World Forum for Harmonization of Vehicle Regulations

Working Party on Lighting and Light Signalling (GRE)

Proposal for Supplement 14 to the 02 series of amendments to Regulation No. 3 (Retro-reflectors)

Submitted by the expert from Germany*

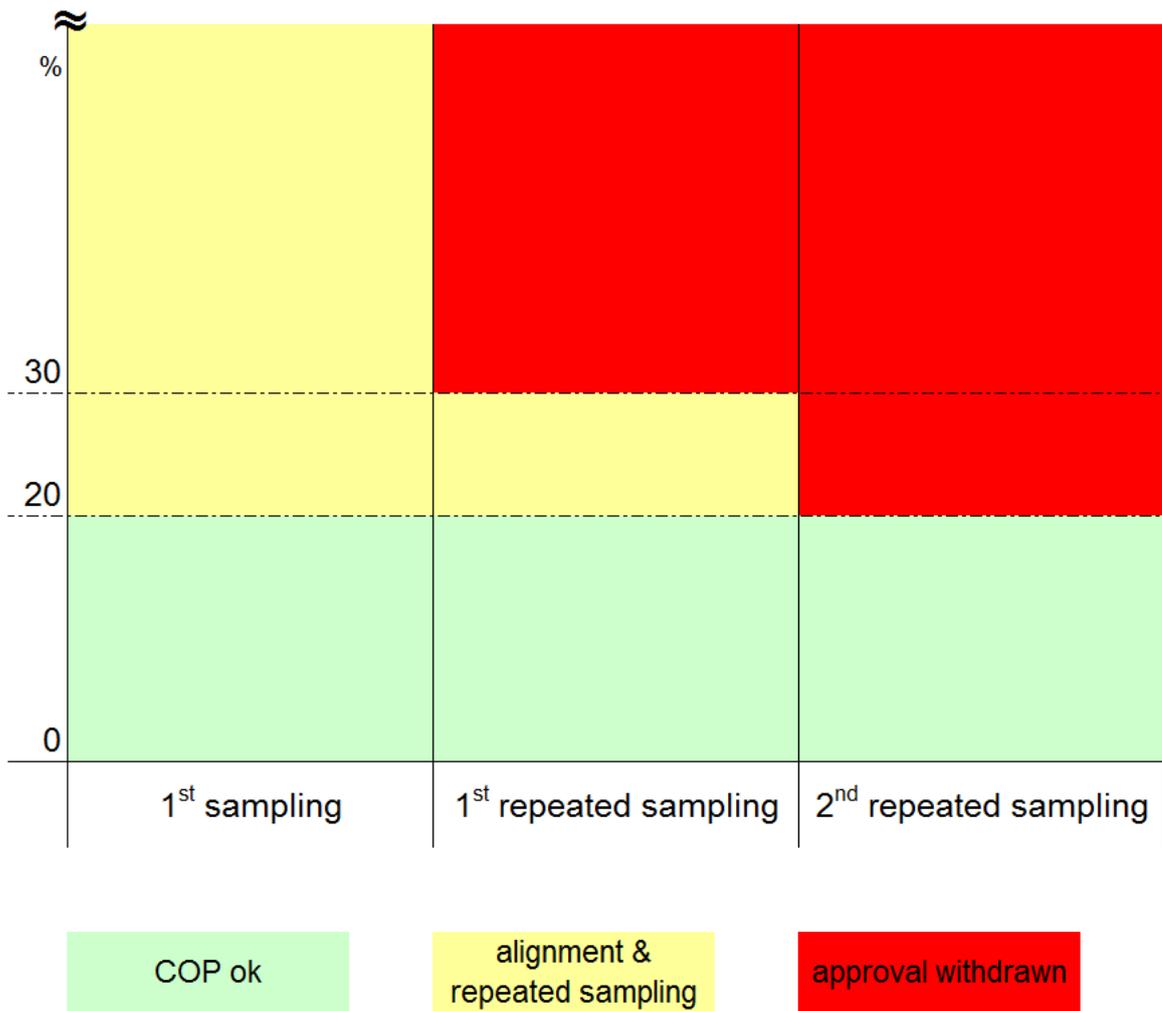
6. CoP is now described in a clear structured stepwise process (with limited steps), which gives the manufacturer the chance in the first step - in the case of deviations of more than 20 per cent - to align his production process. Also, the CoP process can be completed earlier when the first two samples are in the full specifications.

7. The proposal details the "third step" which defines the condition where the approval shall be withdrawn, when after the second repetition of this process the manufacturer was not in the position to "align" his production process in the correct way.

8. The attached drawing shall demonstrate this stepwise process.
